H[®] PRODUCT UPDATE

ULTRAA-K[®] Air Spring Change

LIT NO: P36029

DATE: December 2018

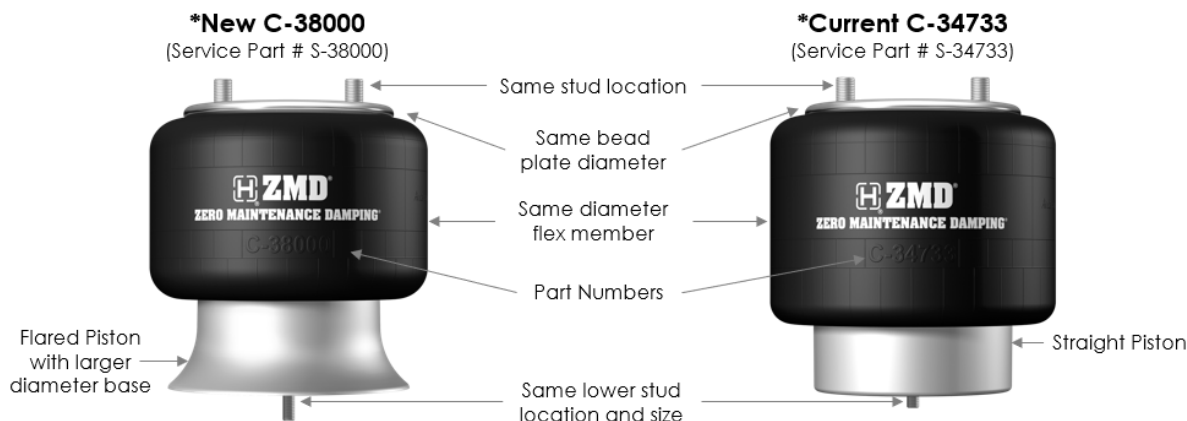
Hendrickson Trailer Commercial Vehicle Systems announces a change to ULTRAA-K[®] air springs. Beginning late Q1 2019, new production ULTRAA-K[®] air slider suspension systems will be equipped with new air springs. The new air spring, featuring a new part number, provides optimized ride dynamics and improved ride quality. It also has a quicker air-up time.

The graphic below illustrates the visual differences between the new production air spring, C-38000, and the current production air spring, C-34733. Please note the stud location of both air springs remains the same.

***Note: These air springs should NOT be mixed on the same air slider suspension system.**

Although both the current and new air spring designs will fit the suspension beam identically, they operate at different pressures. Therefore, to maintain proper performance and avoid premature wear, they should **NOT** be mixed on the same slider suspension system. Refer to the chart below to determine which air spring to use when replacing ULTRAA-K air springs.
